RE: NBHS - BG 24-192 - Change Order 33 - Site Revisions at Stadium Plaza

Change Order

Change Order Request 51 - PCO #114 - RFP-20 Site fencing and finish site work at demoed bldg

REQUEST FOR PROPOSAL

A NORTH BULLITT - LAYOUT PLAN

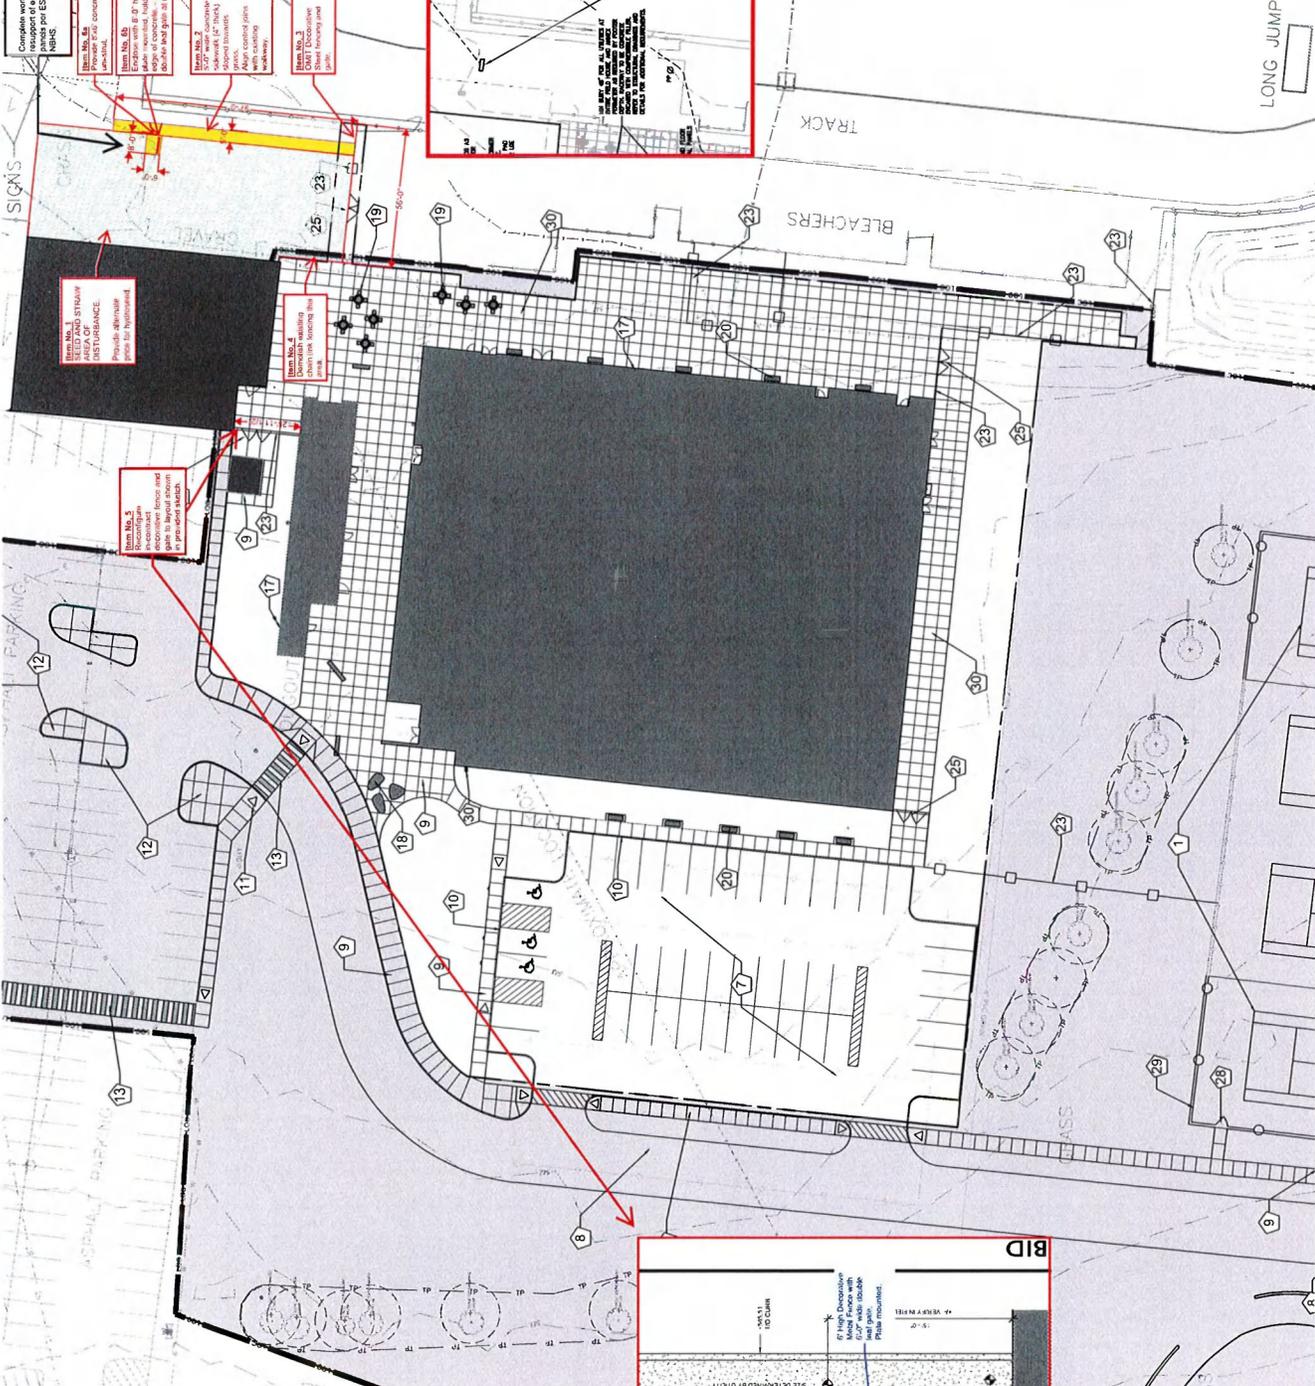
Refer to C1.52 -

- Item No.1** SEED AND STRAW AREA OF DISTURBANCE. Provide alternate price for hydroseed.
- Item No.2** ADD 5'-0" wide concrete sidewalk (4" thick) sloped towards grass. Align control joints with existing walkway.
- Item No.3** OMIT Decorative Steel fencing and gate.
- Item No.4** Demolish existing chain link fencing south of baseball building.
- Item No.5** Reconfigure in-contract decorative fence and gate to layout shown in provided sketch.
- Item No.6a** Provide 8'x6' concrete pad under exiting panels after uni-strut supports are built.
- Item No. 6b** Enclose panels with 8'-0" high chain link fence, plate mounted, hold fence back 6" from edge of concrete pad.
- Provide(1) 6'-0" wide double leaf gate at north side of enclosure.
